# UNITED STATES PATENT AND TRADEMARK OFFICE

APPLICATION NO.	FILING DATE	FIRST NAMED INVENTOR	ATTORNEY DOCKET NO.	CONFIRMATION NO.
10/005,290	12/04/2001	Mark Dinsmore	PHLL-154	6794

# Office Action Summary

FIG. 1

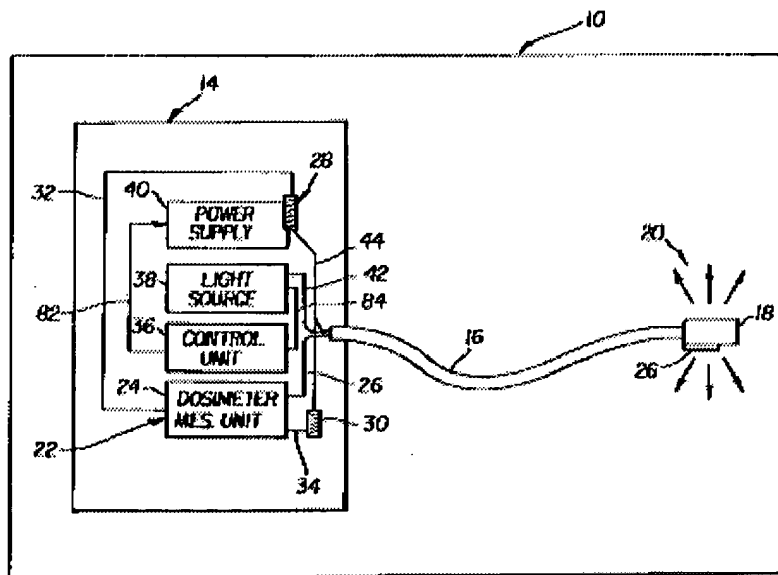
With respect to claim 1 and 24 Shinan shows (Figs.1-3) a therapeutic radiation source (10), comprising: a probe assembly including an optical delivery structure (16) having a proximal end and a distal end, the optical delivery structure (16) being adapted for transmitting optical radiation incident on the proximal end to the distal end; an optical source (38), including means for generating a beam of optical radiation directed to the proximal end of said optical delivery structure;

electrons from the electron beam (62); means (40) for providing an accelerating voltage between the electron source (52) and the target element (54) so as to establish an accelerating electric field which acts to accelerate electrons (62) emitted from the electron source (52) toward the target element (54); and (see abstract) an in situ radiation detecting system (22) for monitoring an amount of the therapeutic radiation (20) emitted by the target element (54), the radiation detecting system (22) including: a scintillator (26) disposed along a path of the therapeutic radiation (64 as part of 20) emitted by the target element (54) and adapted to generate scintillator light (66) in response to the therapeutic radiation incident (64) thereon, wherein the intensity of the scintillator light (66) is proportional to the intensity of the incident therapeutic radiation (64); a photodetector (46) in optical communication with the scintillator (26) for converting the scintillator light (66) into a signal indicative of the intensity of the incident therapeutic radiation (64) (column 5; line 57 – column 8; line 58).

FIG. 3

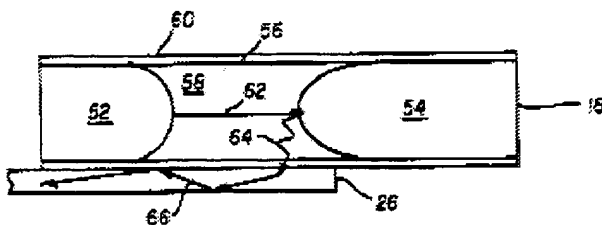
With respect to claims 25 and 26, Shinar teaches that the radiation generator assembly further comprises a capsule enclosing the electron source (52) and the target element (54) and defining a substantially evacuated interior region extending along a beam axis (Fig.3) The means for providing an accelerating voltage comprises a high voltage power supply (column 9; table 1).

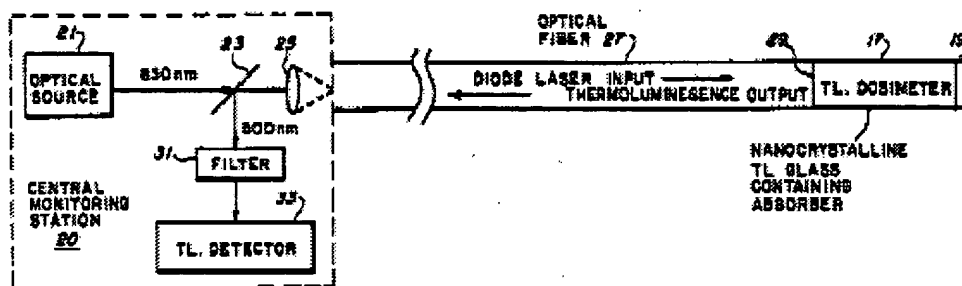
With respect to claims 19-21, Shinar teaches that scintillator can be made from any appropriate material with many modification and variations (column 10; lines 38-45). It would have been obvious to one having ordinary skill in the art at the time the invention was made to provide the scintillator made from: a crystalline material; or material selected from the group consisting of sodium-iodide, cesium-iodide, bismuth-germinate, cesiumfluoride, ZnS, YAP:Ce (yttrium aluminum perovskite), terbium doped glass fiber; or material selected from the group consisting of glass, terbium doped glass fiber, and polymers, since it has been held that to be within the general skill of a worker in the art to select a known material on the bases its suitability for the intended use. In re Leshin, 125 USPQ 416.
